## SUBDIVISION REVIEW SHEET

**CASE NO.:** C8-2022-0169

**SUBDIVISION NAME:** Evelyn Tract Preliminary Plan

**CITY OF AUSTIN –DEVELOPMENT SERVICES DEPARTMENT  
SUBDIVISION APPLICATION – MASTER COMMENT REPORT**

LOCATION MAP

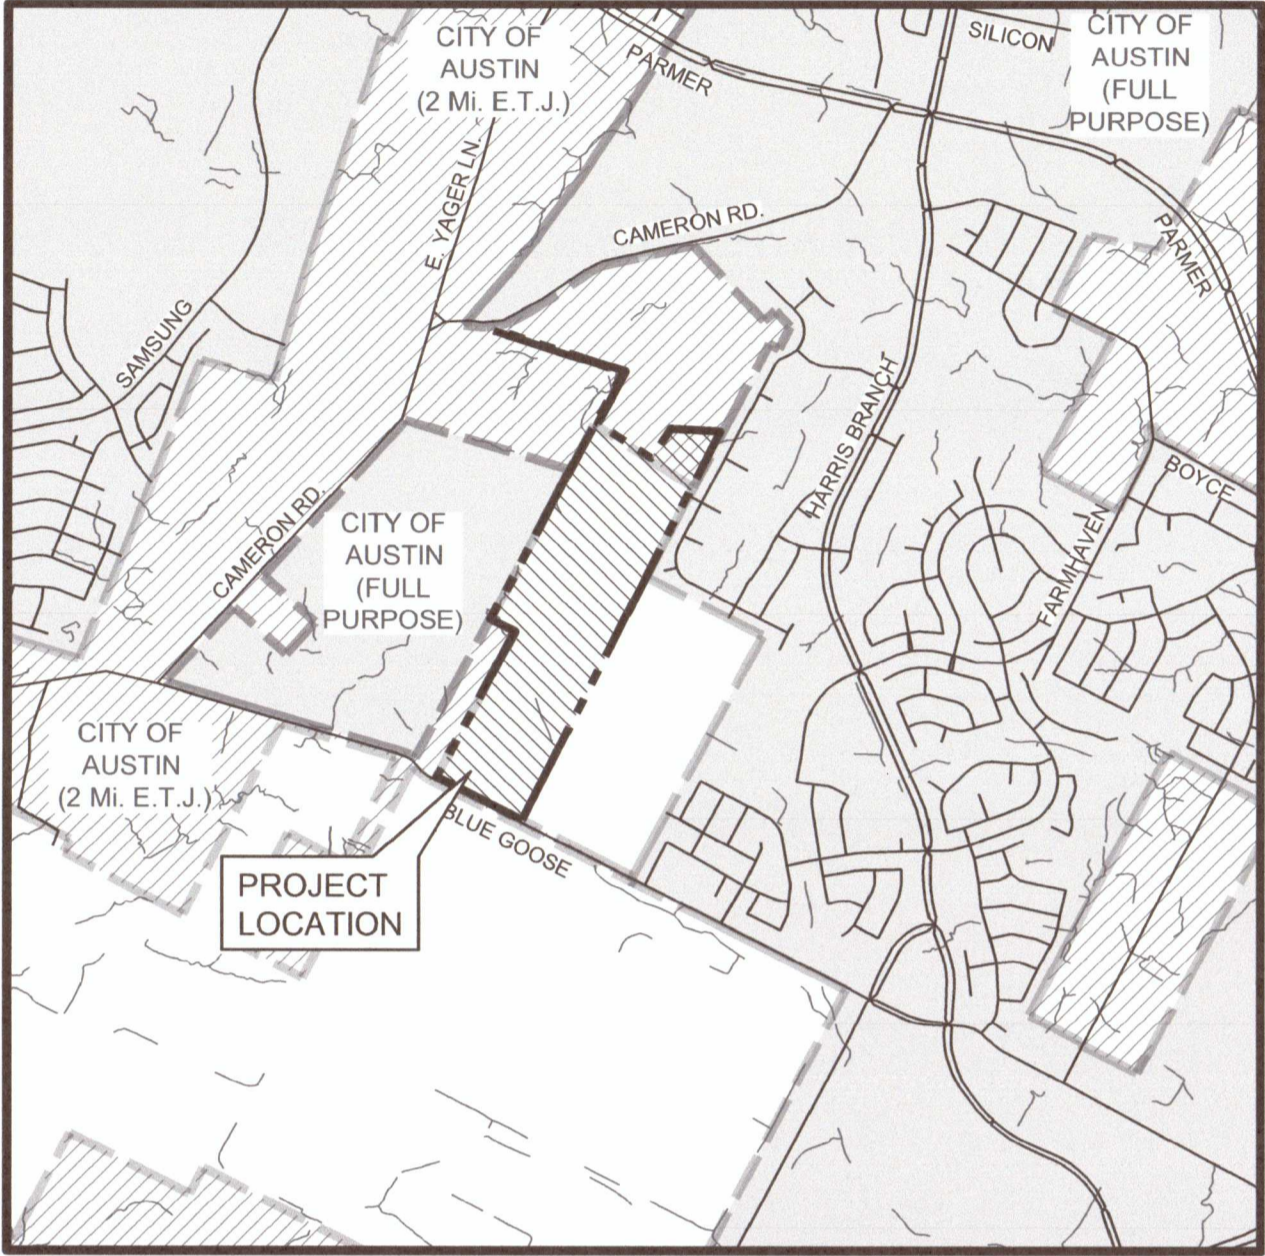
AD6: In the location map, please update PARMER to E PARMER LN as it reads here.

GENERAL NOTES

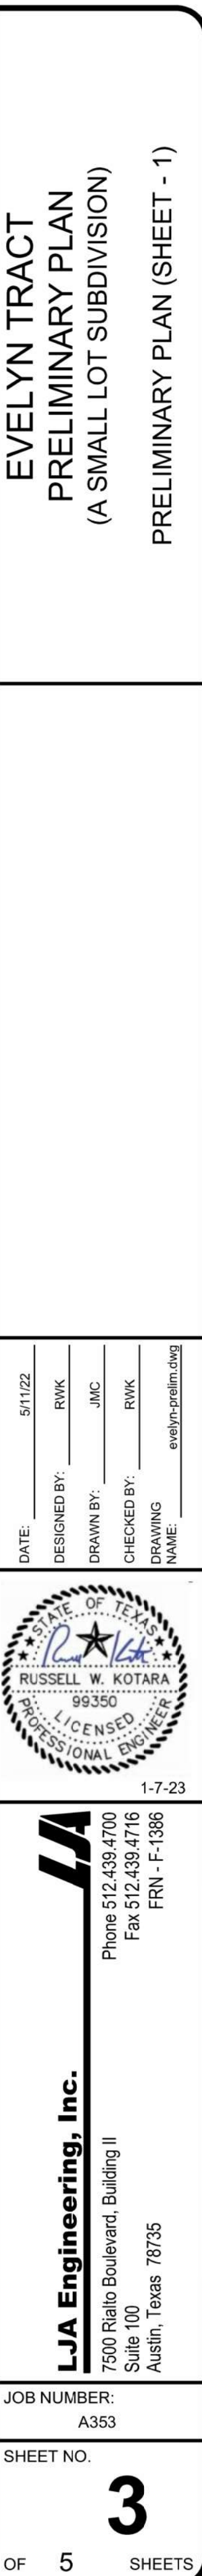
- SR 3. Verify that Note #30 list all the lots accordingly, it appears lots are left off the note, such as Lot 3 Block P, and Lot 25 Block M. LDC 25-1-83

Note 6: Remove "WATER SUPPLY AND WASTEWATER COLLECTION" from this note. Fiscal is not collected for water and wastewater improvements.

Replace note 11B with the following note.

Remove notes 11E through 11H. These are duplicate notes of 12A through 12D.

EVELYN TRACT  
PRELIMINARY PLAN  
(A SMALL LOT SUBDIVISION)  
PRELIMINARY PLAN (SHEET - 2)

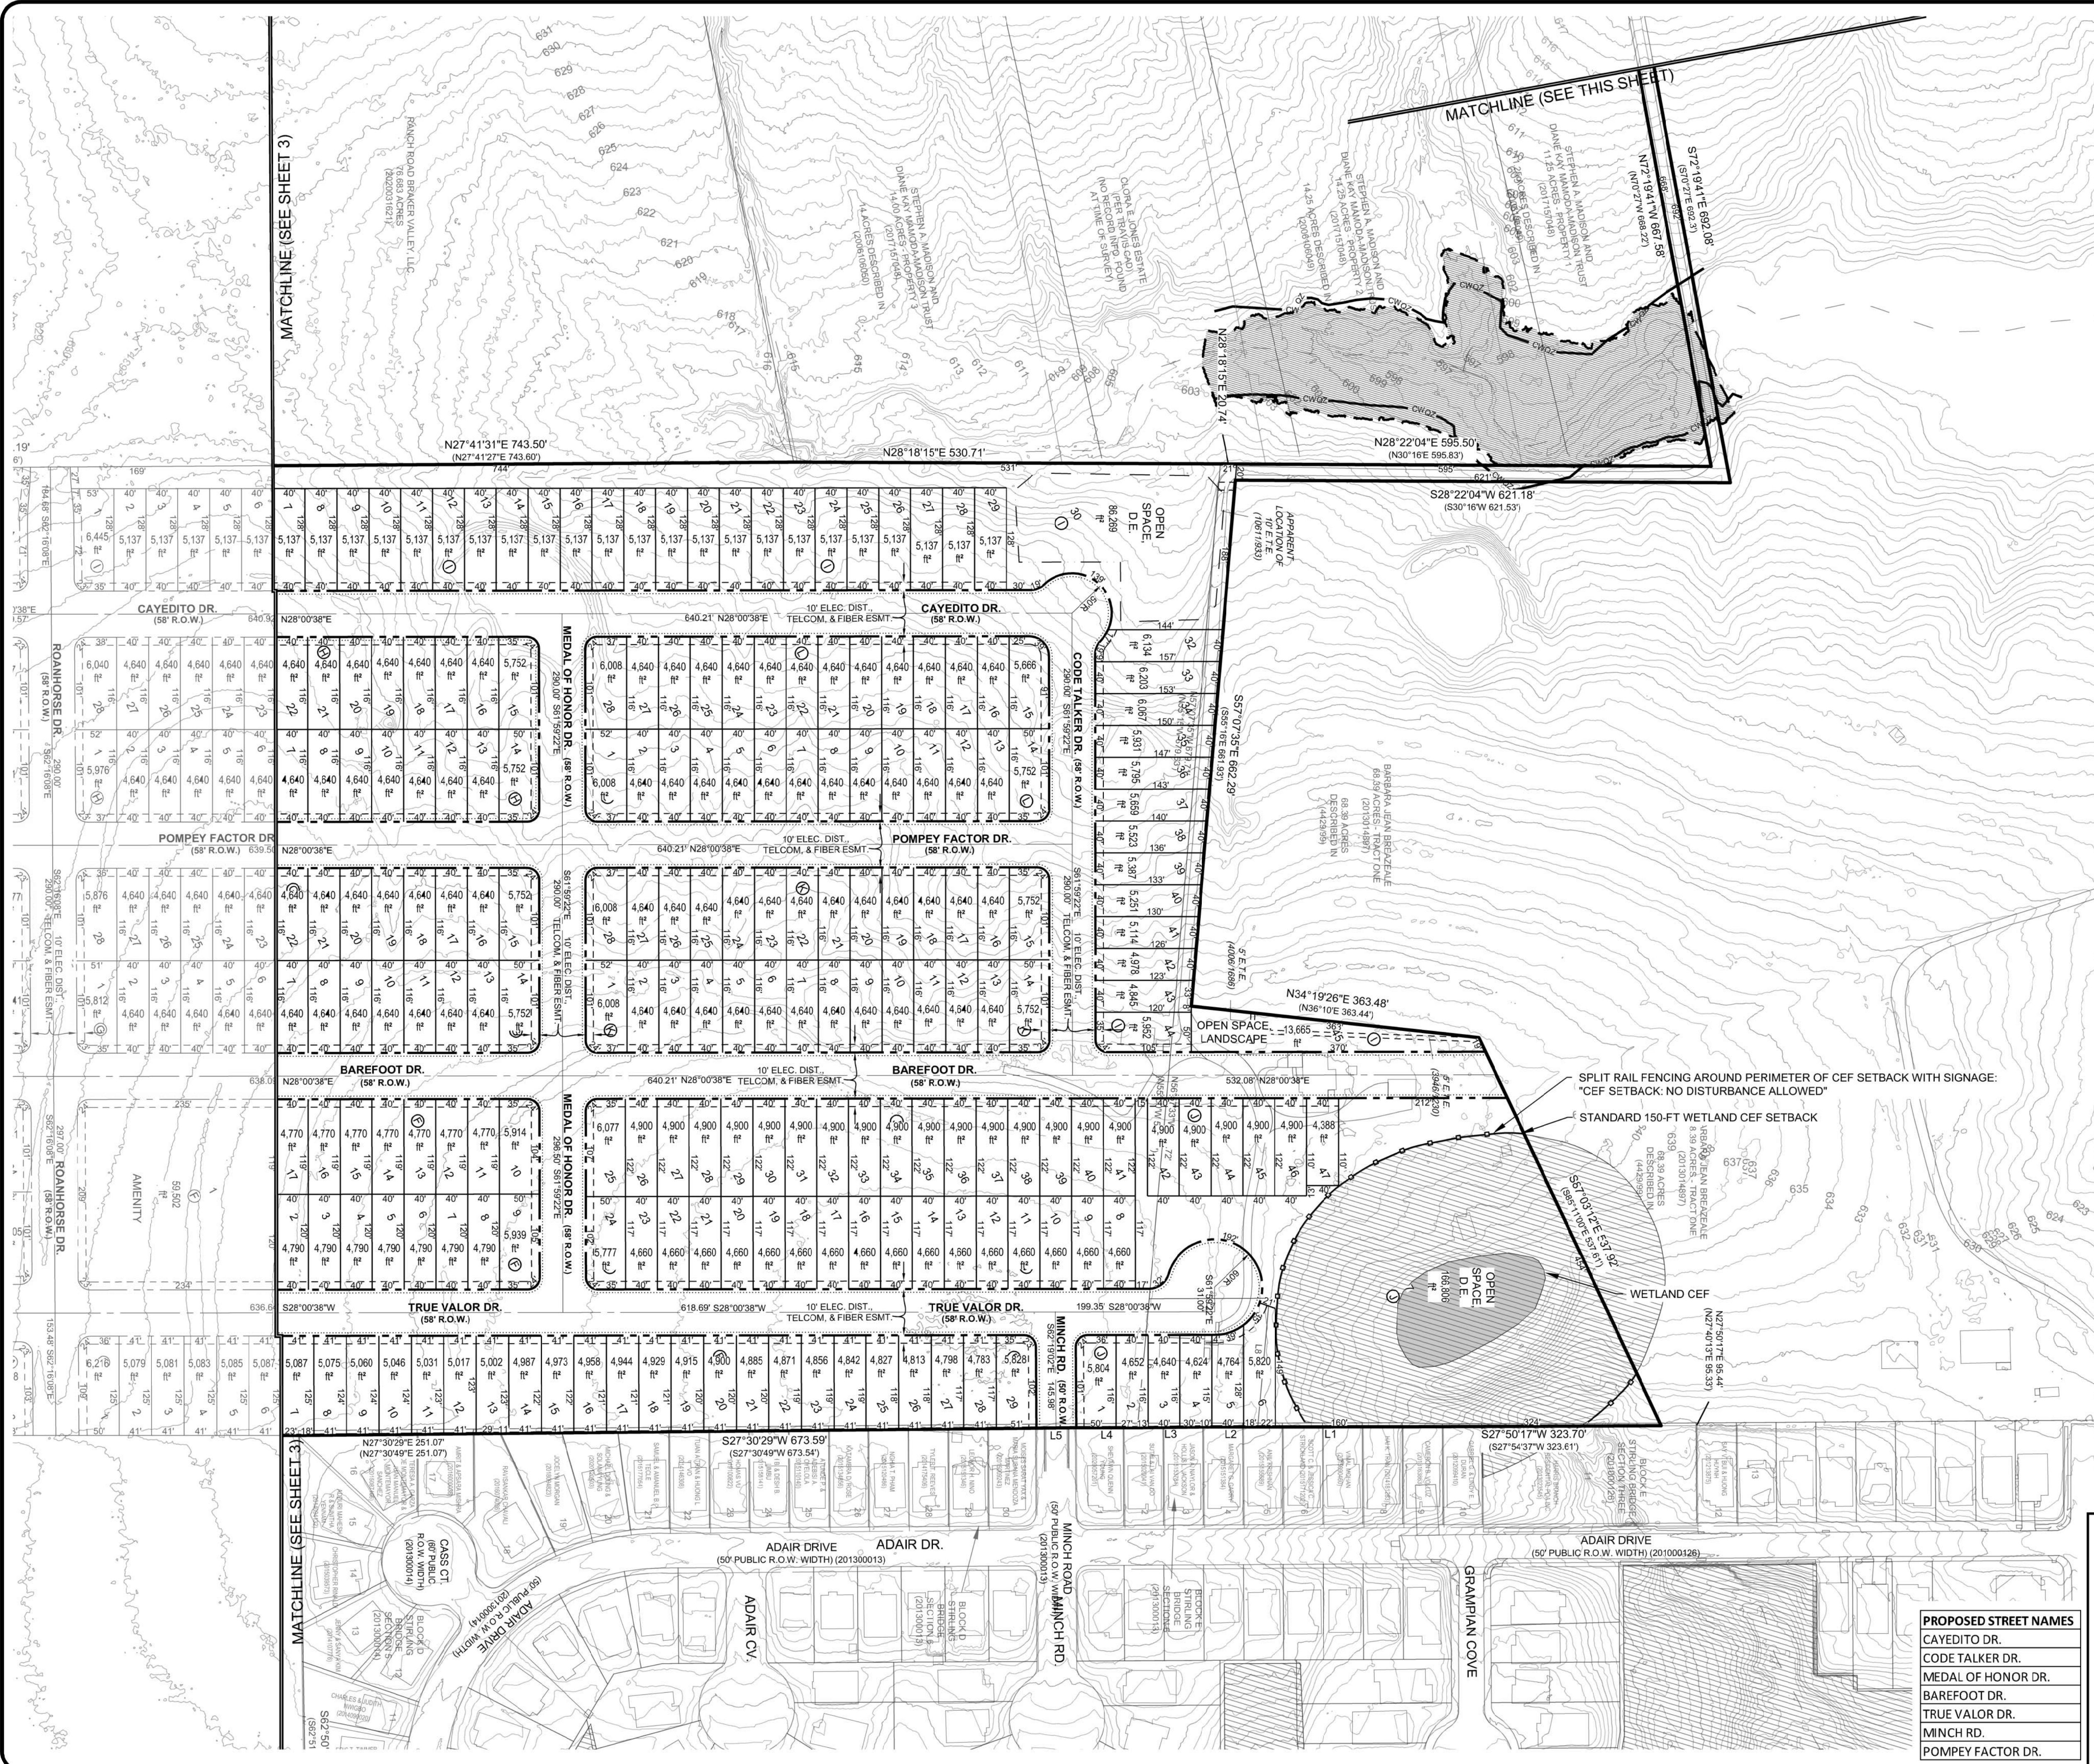
Approved. Please show all open space that isn't also a drainage easement as PUE.

AD3: Please update the label for BLUE GOOSE RD on all sheets, the street type RD must be included.

AD4: Please remove all forms of punctuation after abbreviating street types or directionals on all sheets including the location map.

AD5: BAREFOOT DR is rejected for use. You may add a modifier (second word) to the street name to make it unique or propose a new street name for review. Please submit proposed street names to Address Management Services prior to resubmittal.
